State of Alaska
Department of Fish and Game
Nomination for Waters
Important to Anadromous Fish

Name of Waterway Taylor Creek

106-43-10470 -2008

Correction X

TOWERS ARM
Tidal Flat
Taylor
Creek
106-43-47
corrected
map
30' (PETERSBURG C-5)
SCALE 1:63360
4 MILES
21000 FEET
5 KILOMETERS
CONTOUR INTERVAL 100 FEET
INTERIOR-GEOLOGICAL SURVEY, WASHINGTON, D.C. 11867
ROAD CLASSIFICATION
Trails
ALASKA
(PETERSBURG C-4)
56°45'
133°20'
6291000m.N.
601000m.E.

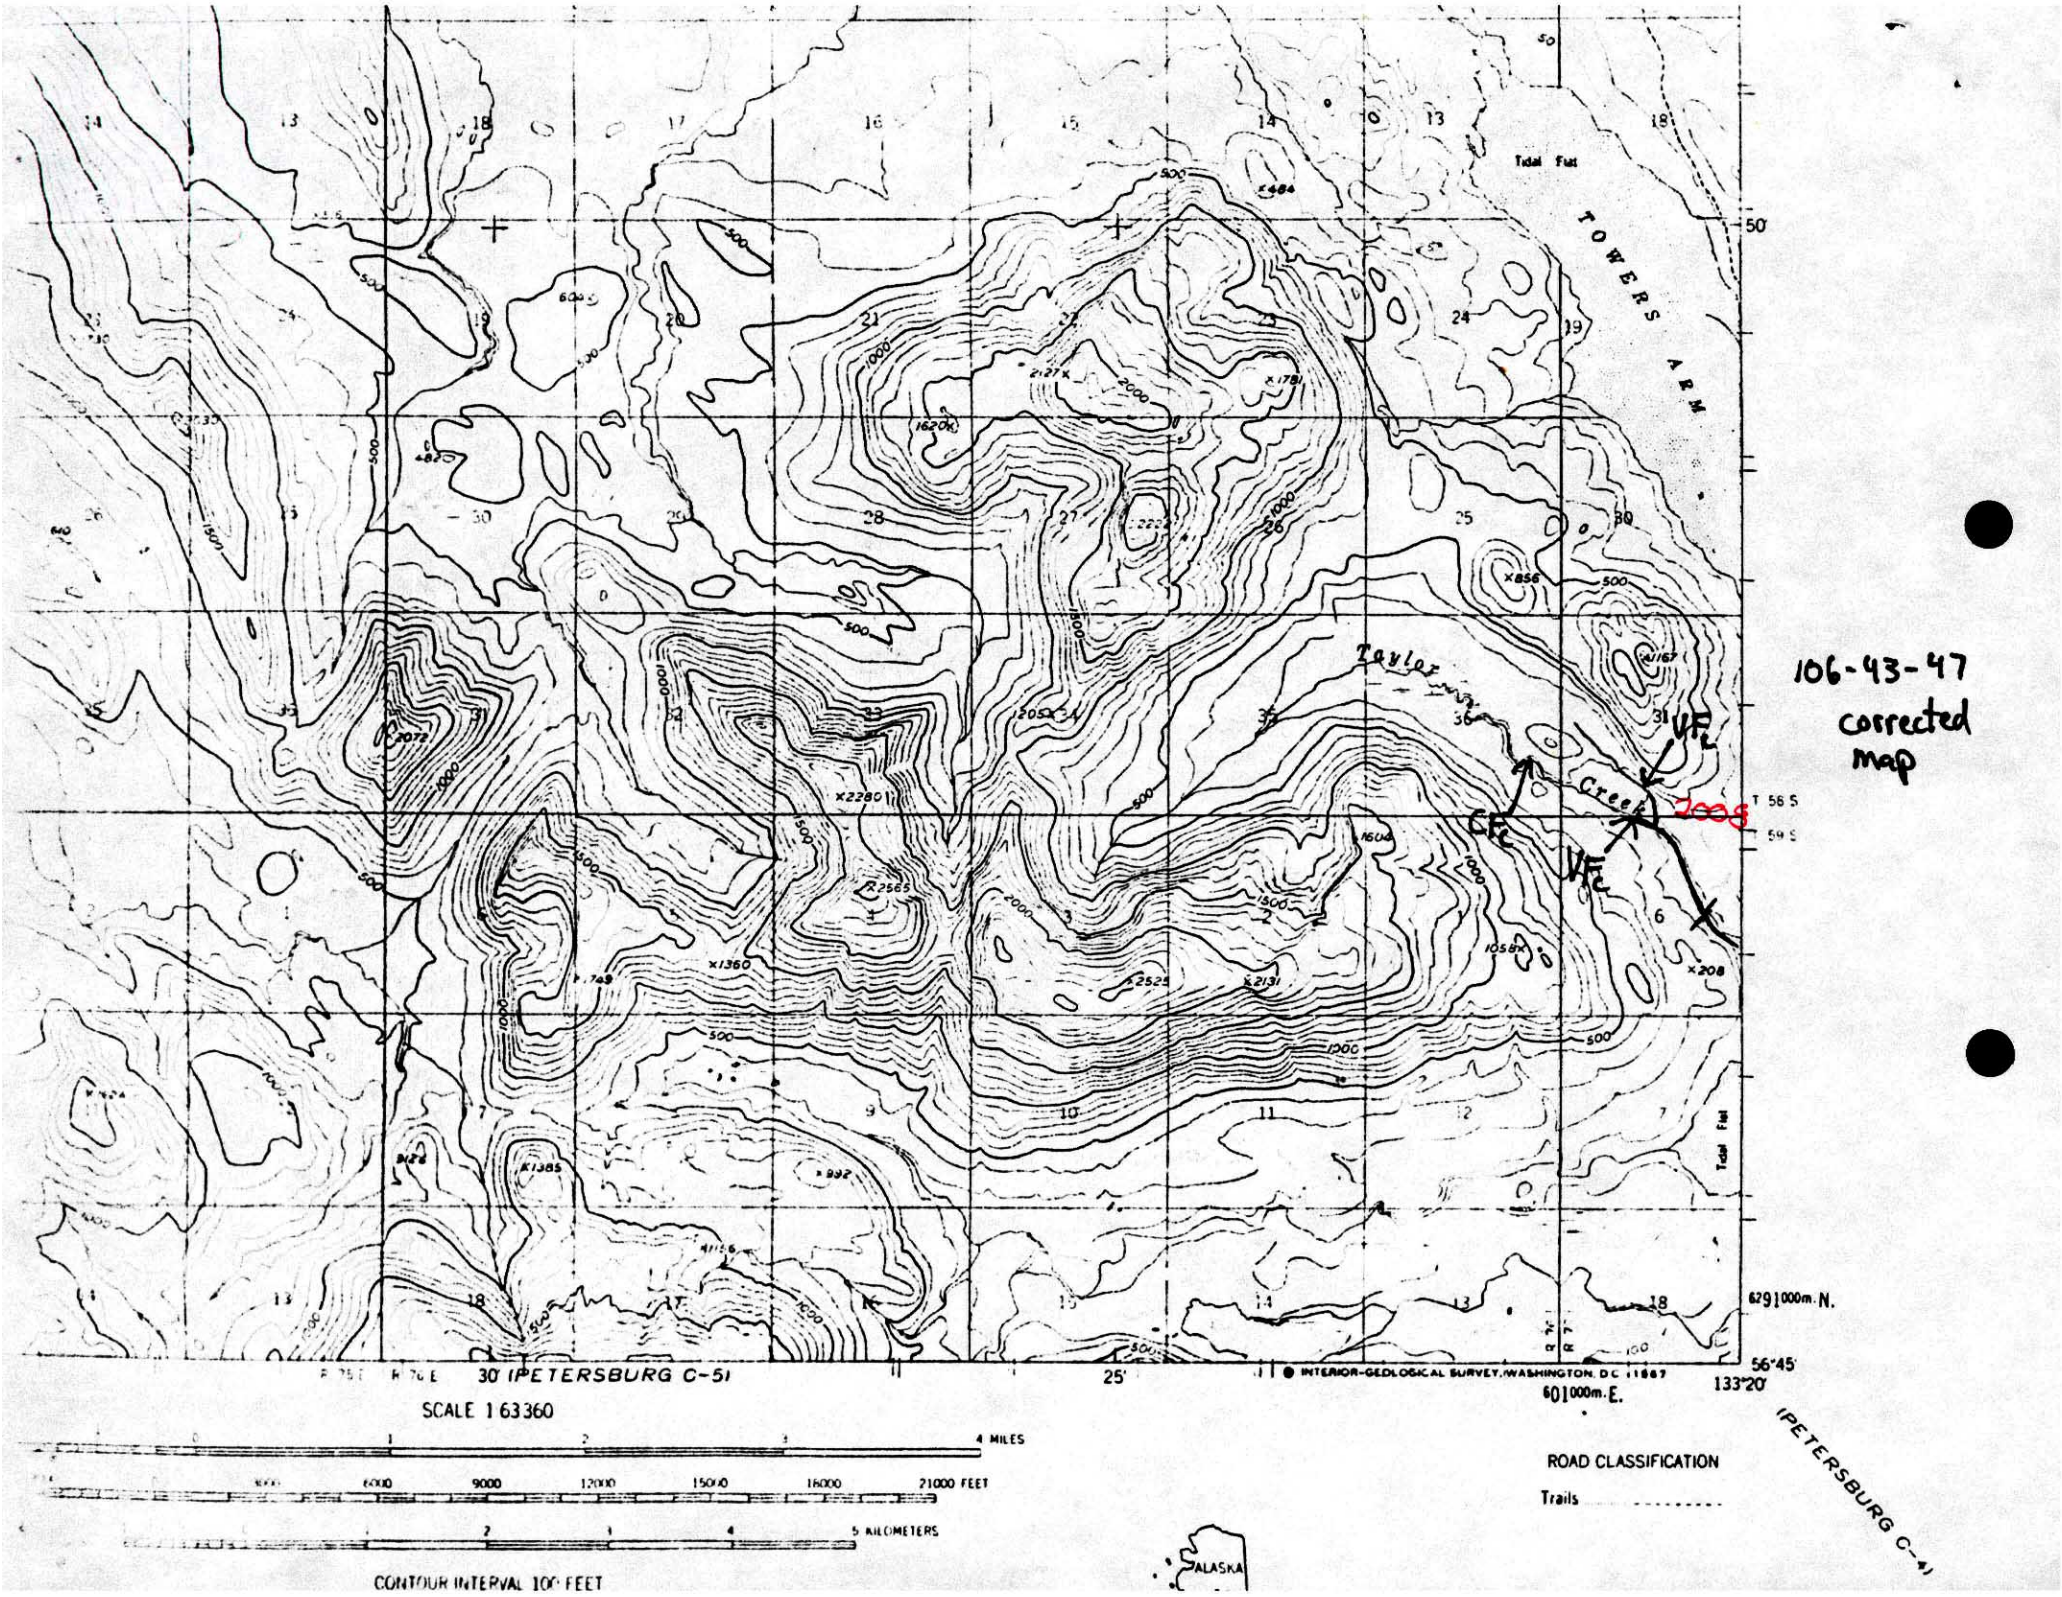
The anadromous reach needs to be shortened because of a barrier bedrock falls that was sighted during a helicopter survey of the stream. The falls appears to be about 10 meters in height. In addition, another probable barrier was sighted about ½ mile upstream from the first falls. No sampling was done on the stream.

A small tributary enters from the north bank about 400 meters below the first falls. It is probably accessible to anadromous use for about 400 meters. The tributary was not sampled. However, the tributary was surveyed by foot for a short distance upstream. A series of 1 to 2 meter bedrock falls that most likely form barriers to fish passage were found and marked on the enclosed corrected map.

The habitat was of minimal quality due to the bedrock substrate and lack of cover in the area of the small bedrock falls. The 400 meter strech below the falls however, appeared from the helicopter to have suitable substrate for spawning and good rearing habitat.
